Delmore Fast-Track

25/06/2025 – Auckland Council Response

MEMO

Subject: Geotechnical Regulatory Engineering Review
Fast Track Application – BUN60444768
88 Upper Orewa Road, Upper Orewa

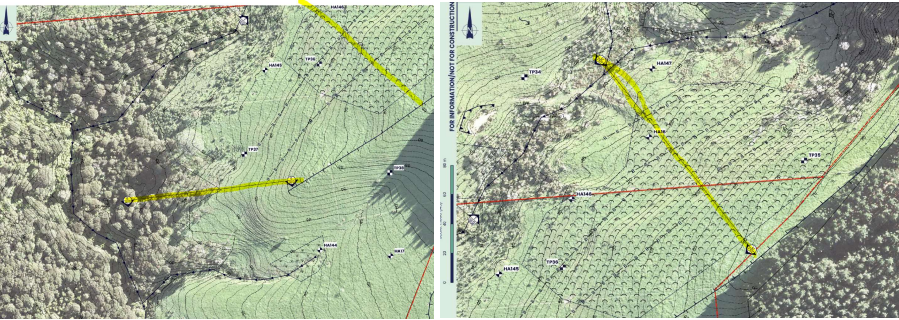
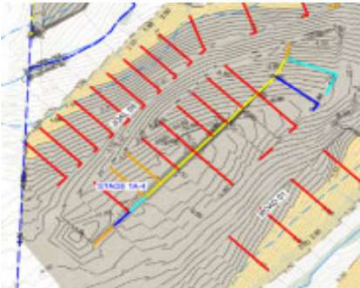
19	Remediation plan	We note the presence of steep cut batters at Stage 1A-4 along the shared boundary between Lots 173 to 182 and Lots 184 to 194, as well as along the north-western boundary of Lots 254 to 256. The gradient of these cut batters is not clearly indicated, and it is unclear how these will be managed in the long term. If specific design zones, MSE walls, or other forms of slope remediation are required, the remediation plan should be updated accordingly to address these areas.	Y		<p>We have reviewed the batter slopes in the vicinity of Lots 173-182, 184-194 and 254-256. For Lots 173-182 and 184-194, a retaining wall is proposed (refer McKenzie & Co drawing 3725-1-2506) between these blocks of lots there is a 1v in 3h batter above and below the retaining wall.</p>  <p>For lots 254-256, the RCB is proposed to be extended to provide support to the downslope edge of these lots. See the snip below in relation to Lots 254 to 256.</p> 	Accepted and closed.
